**Service Bulletin**

**No. : MZ07-041**

**Model:** MA9S2

**Subject:** Improvement for Oscillation and adjust audio quality with this modification.

## NO. 1 ADDING A PWB

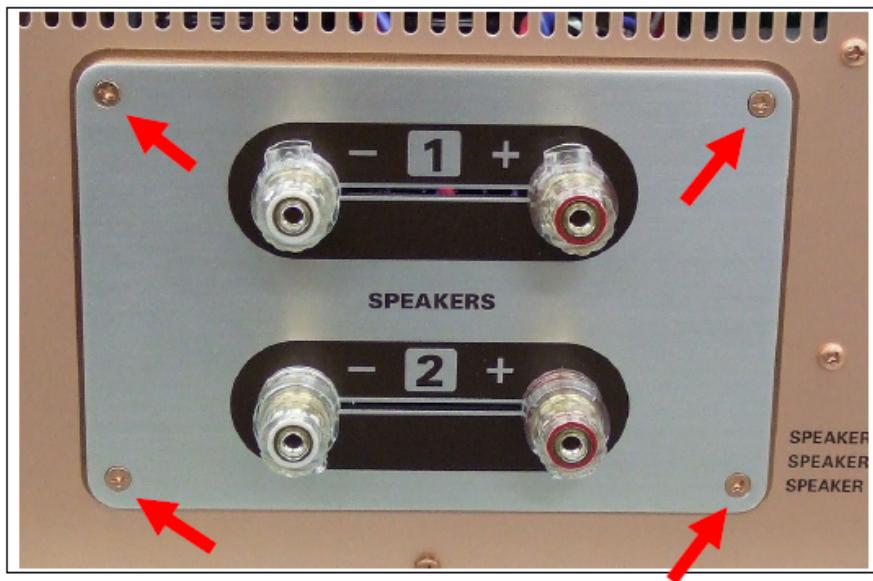
1) Screw down a PWB ASSY P371 and a P381 to the REAR PANEL.

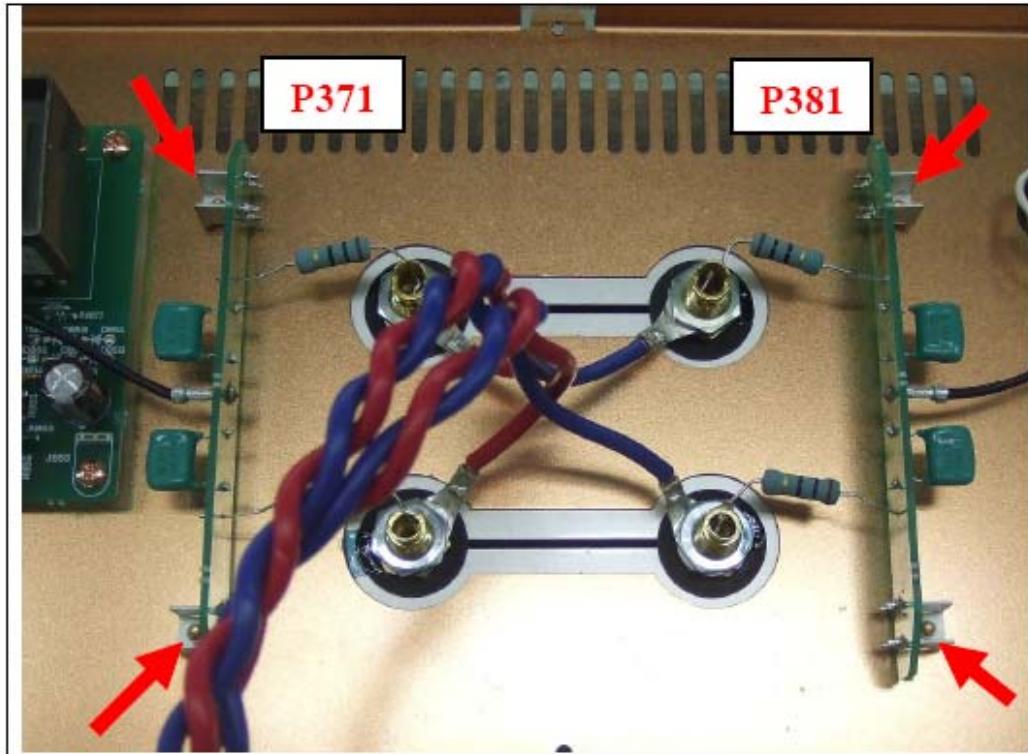
2) The screws to be used are preexisting on the REAR PANEL. Slacken the screws once and then screw up the arrowed terminals.

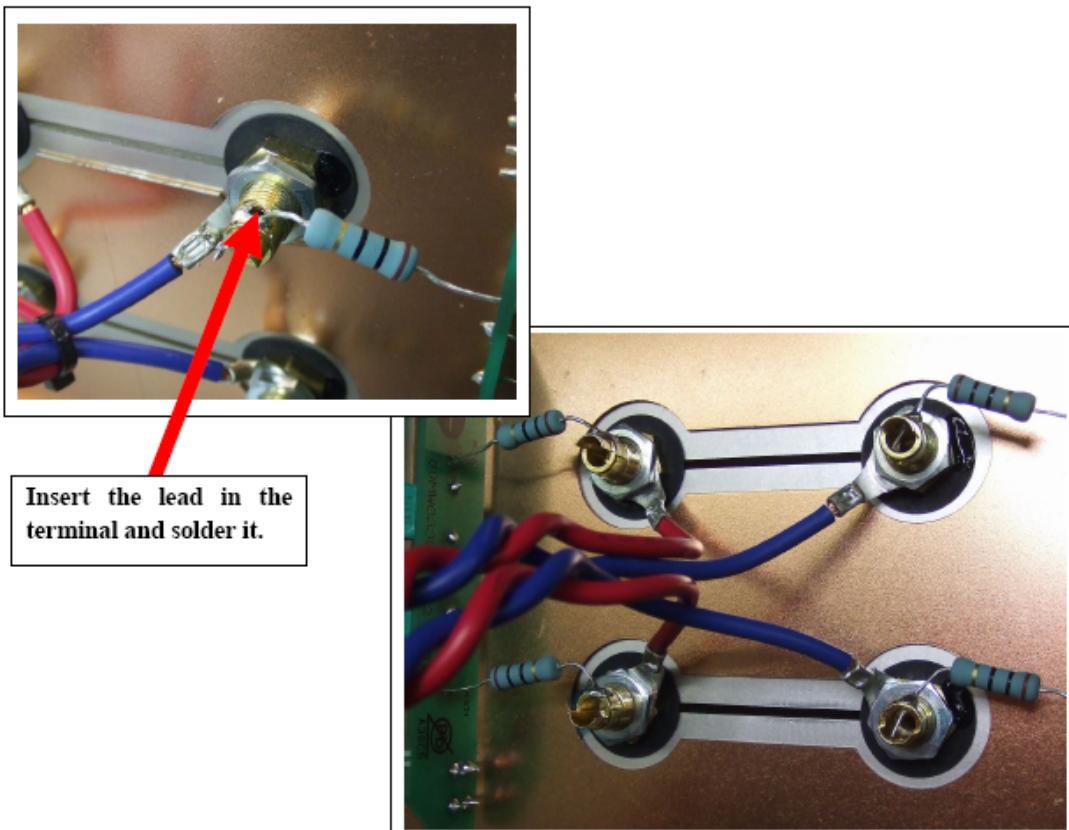
3) Insert the leads of the R371, R372, R381, R382 in the speaker terminals and solder them.

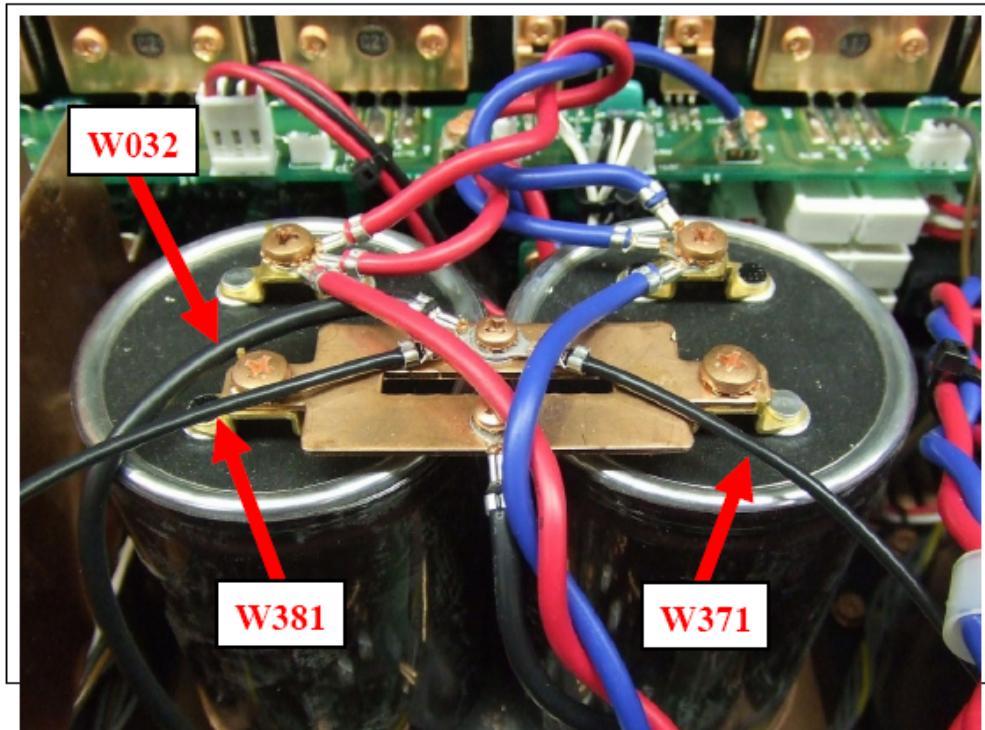
3) Insert the leads of the R371, R372, R381, R382 in the speaker terminals and solder them.

Circuit diagram of the additional PWBs (PWB ASSY P371 & P381)

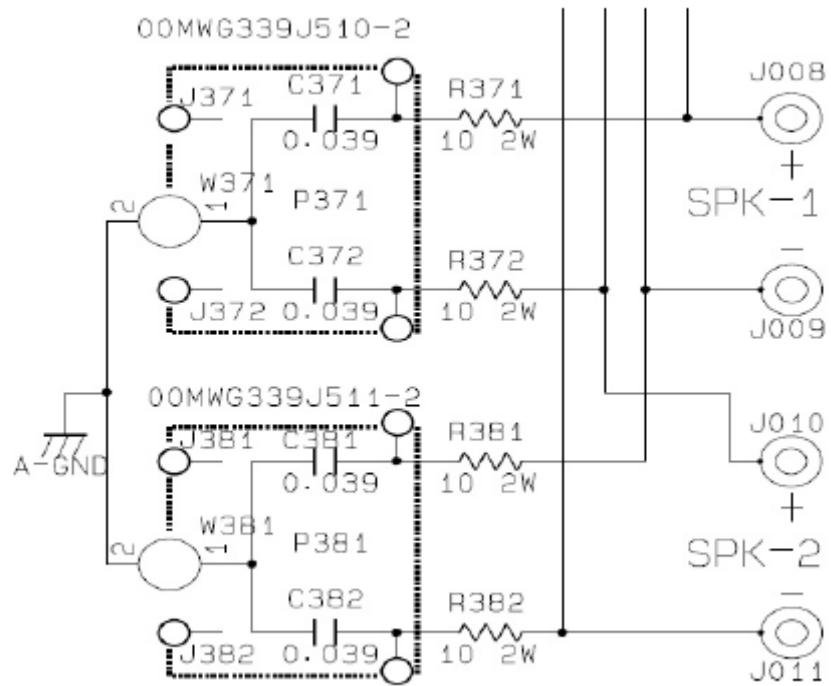
4) Screw down a layer of the earth lugs in the order of W302, W381 and W371 with the preexisting a screw.

## NO. 2 REMOVING C204 FROM PWB P201

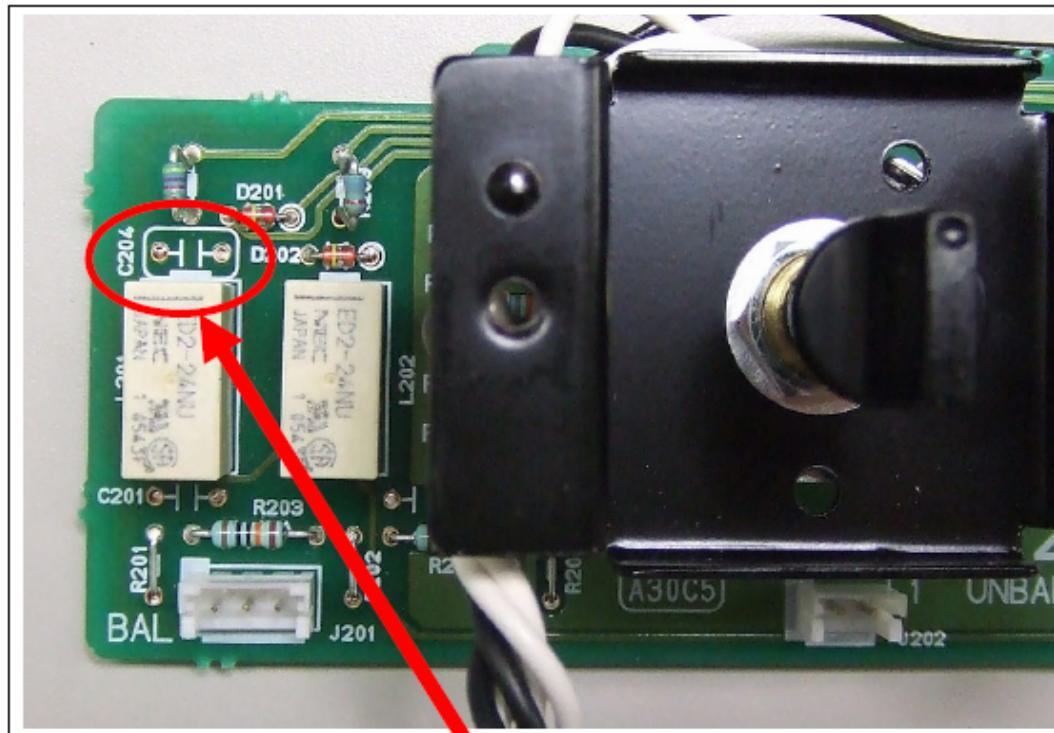
**Remove C204 (220pF)**

## NO. 3 REPLACE C853, C854 & C856, ADD J859 ON PWB P851

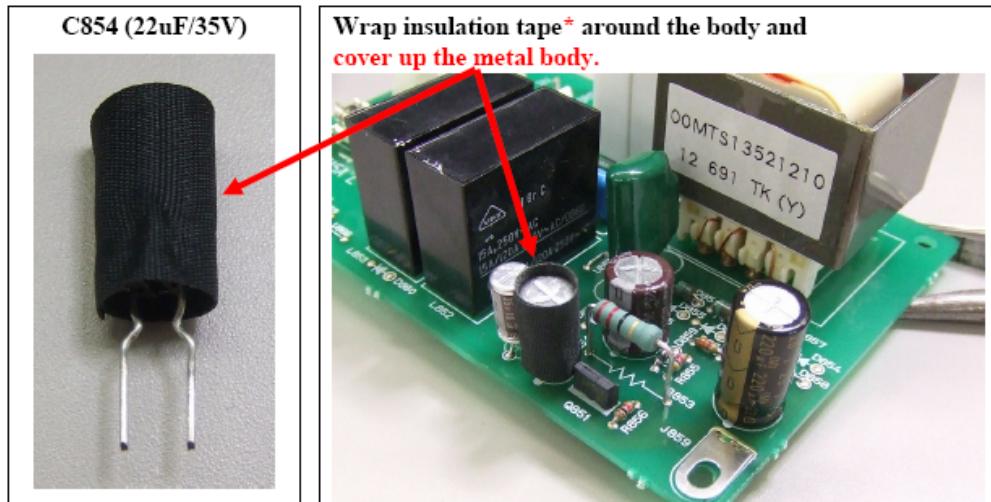
- 1) Wrap insulation tape\* around the C854 capacitor in order to avoid contact and short with the other capacitor that stands side by side.

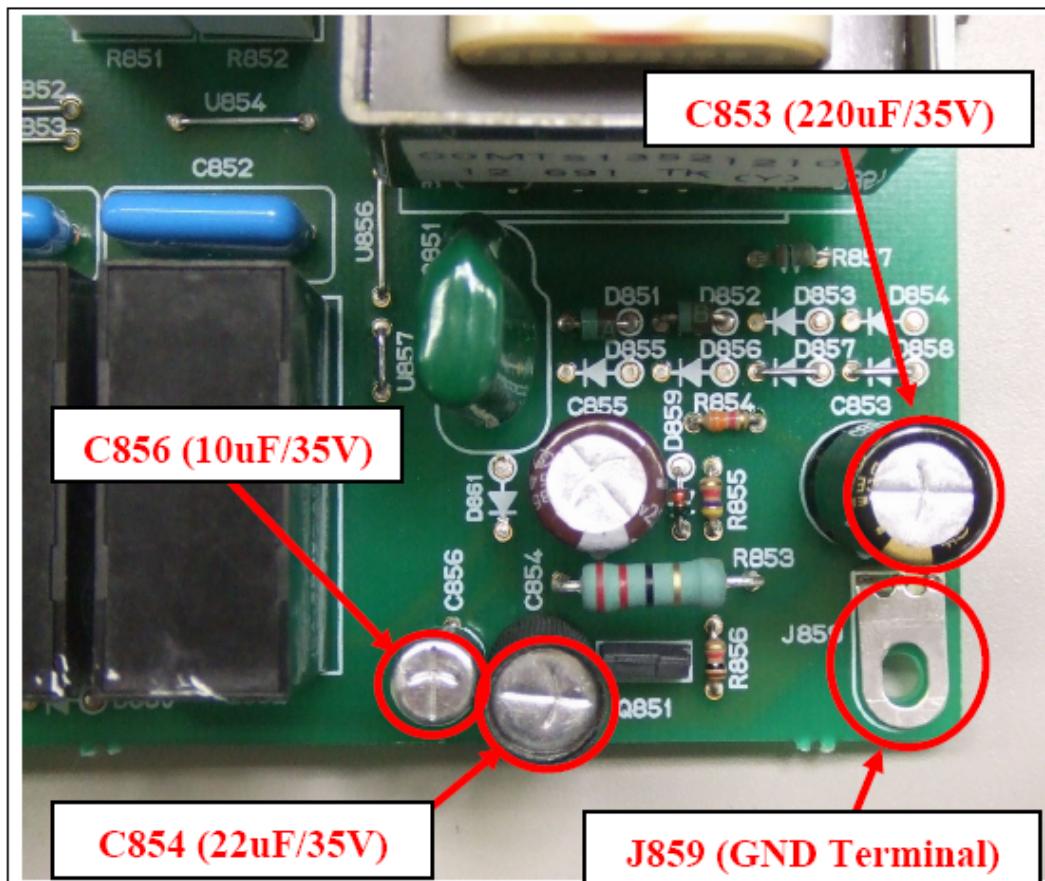
2) Replace the C853, C854 & C856 capacitors; then add a J859 ground terminal.

NO.4 ADD C523, C524, C525 & C526 TO PWB P501

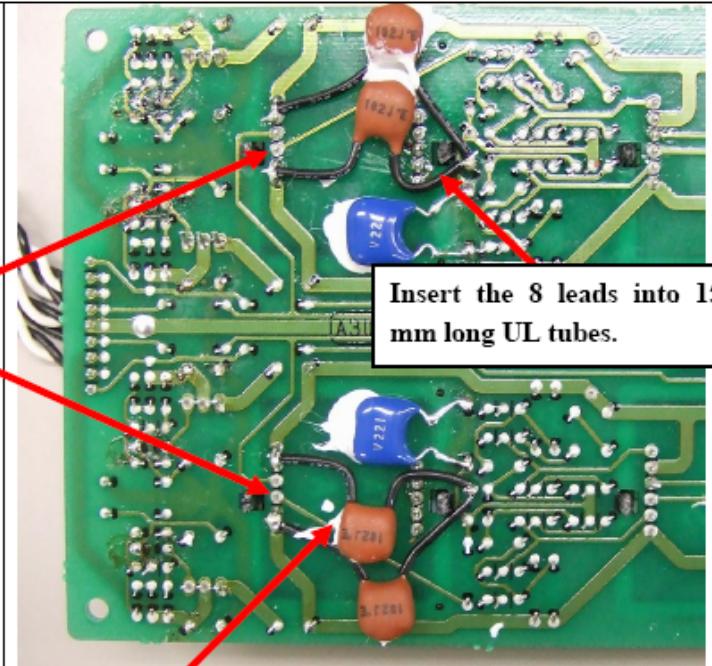
The arrowed rounds can be shorted out.

Insert the 8 leads into 15 mm long UL tubes.

Bond\* C523, C524, C525 & C526 to the board.

**NO. 7 REPLACE C952, C953 & C954 FROM PWB P951; REMOVE C955; ADD C958 & C959**

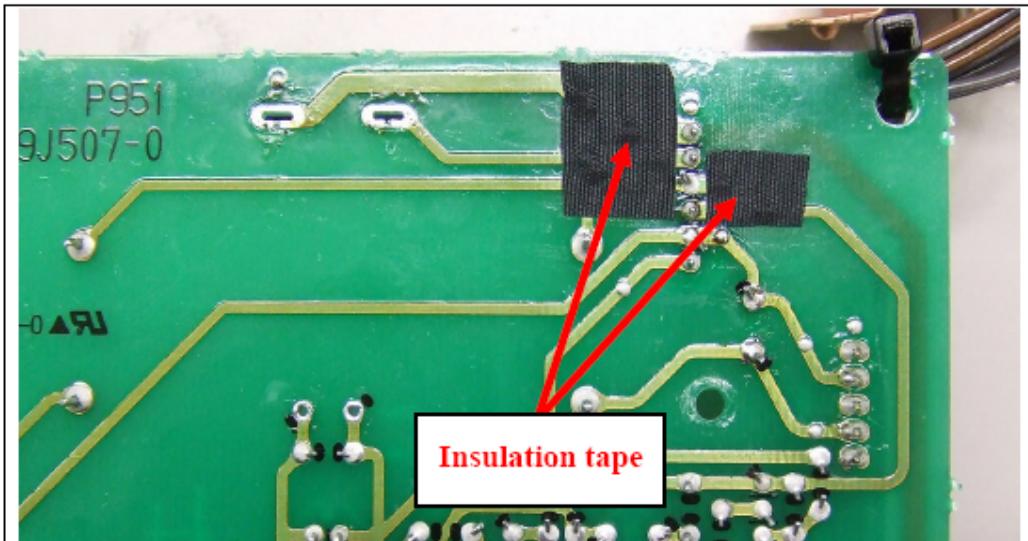
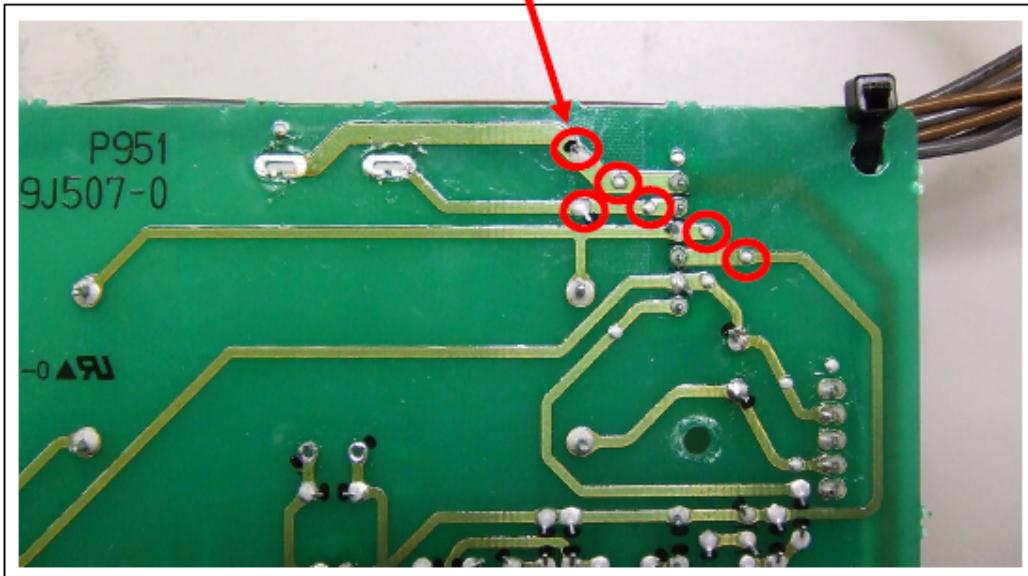
1) Replace the C952, C953 & C954 capacitors; and remove the C955.

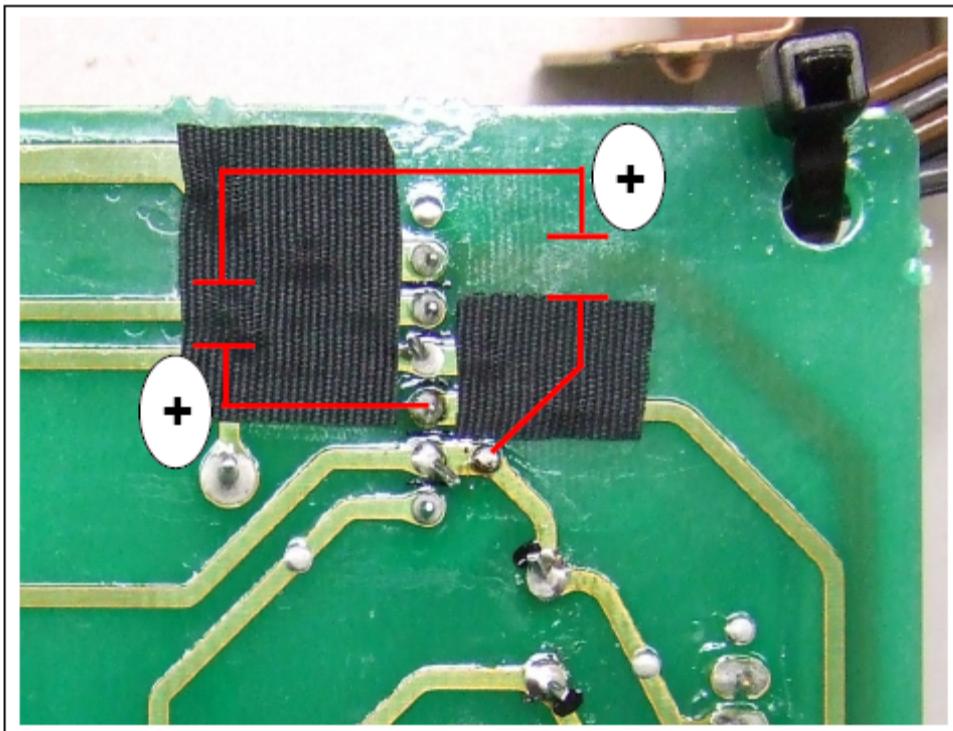
2) Add C958 & C959.

Firstly, for insulation purposes, put strips of insulation tape\* on the PWB P951.

**Cover the circled 6 lands with insulation tape\*.**

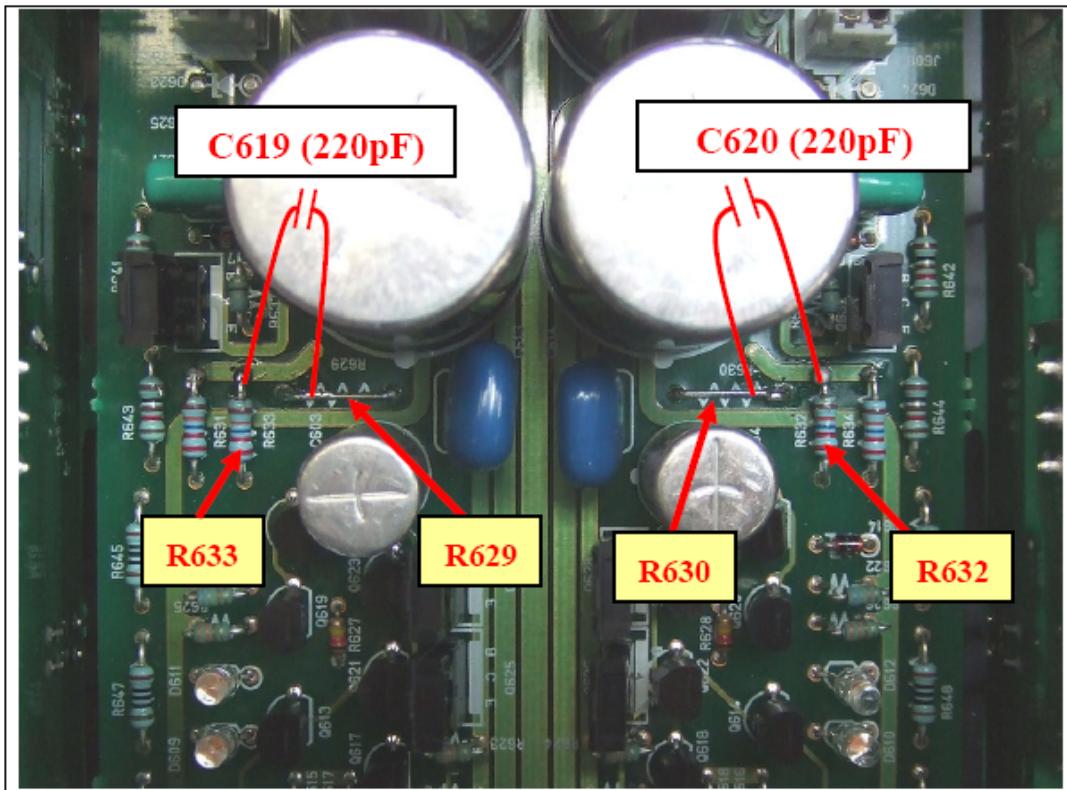
**Solder and then bond\* to the PWB.**

## NO. 8 ADD A C619 & C620 TO PWB P601

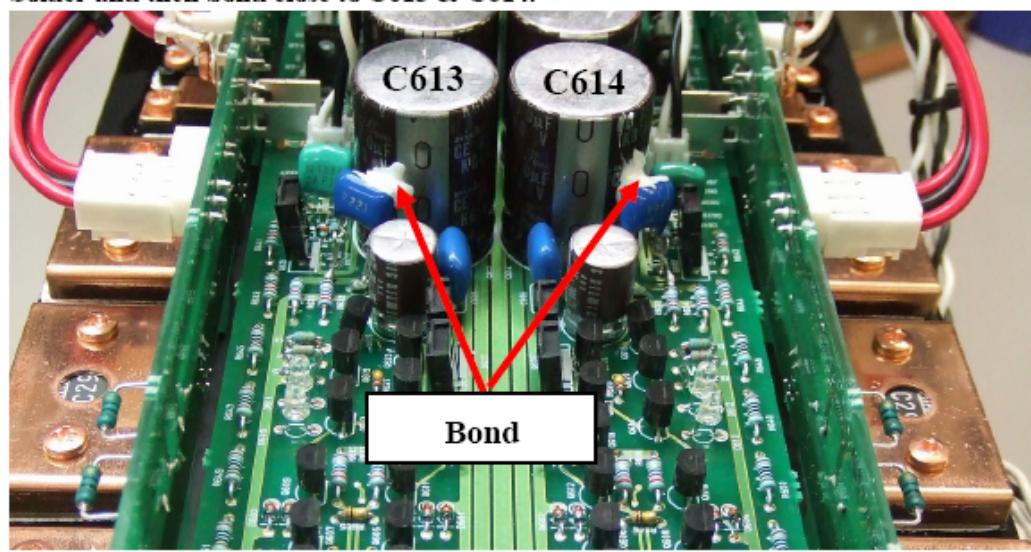
- 1) Solder C619 to one lead each of R633 and R629.
- 2) Solder C620 to one lead each of R632 and R630.

Solder and then bond close to C613 & C614.
